# Safety Evaluation Report

NUREG-0308

## Arkansas Nuclear One, Unit 2

November 1977

FIGURE D-2 MACS UNIVERSAL CHASSIS - CEAC

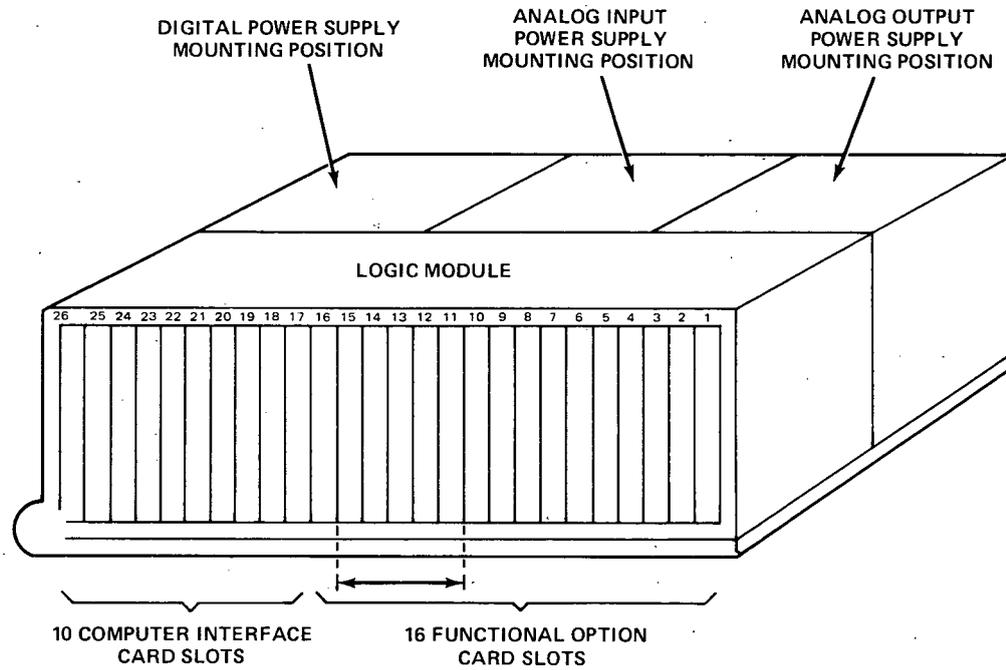
encompass the output cards to channels D, C, plant computer, B, and A respectively. Refer to Figure D-2, "MACS Universal Chasis-CEAC." All five cards are within a 3.5-inch proximity. We required the applicant to identify their design basis events for the CEAC and verify that no single event either internal or external to the CEAC will result in the loss of function. Refer to Table 7.1, Position 4, for more detail.

The isolation amplifiers are located in Channels A and D which transmit twenty CEA position informations to the CEA calculators in Channels B and C respectively. This configuration is shown in Figure D-2. These isolation amplifiers are used to maintain channel independence.

Figure D-3  
DNBR Transient  
Four Pump Loss of Flow  
Top Axial Peak

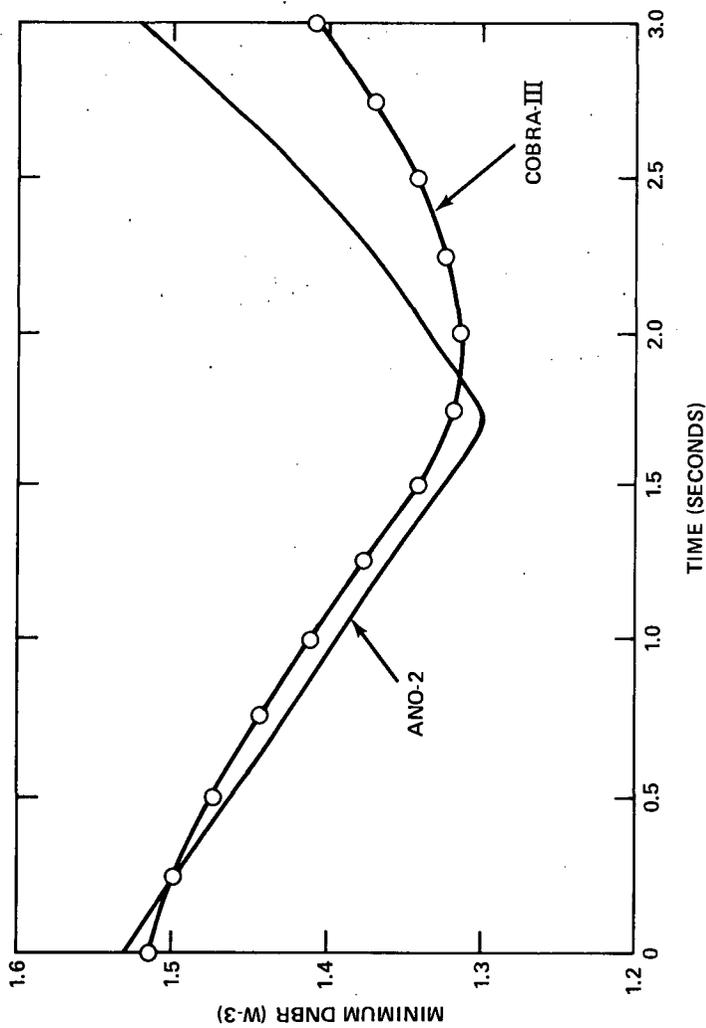
Figure D-3 compares the staff result from minimum DNBR versus time for the top axial peak with the results of the Combustion Engineering analysis. The staff calculation was initiated at a DNBR of 1.515 and reached a minimum of 1.315 at 2.0 seconds. Based on the staff audit calculations, the Combustion Engineering prediction of minimum DNBR for the top axial peak is acceptable.
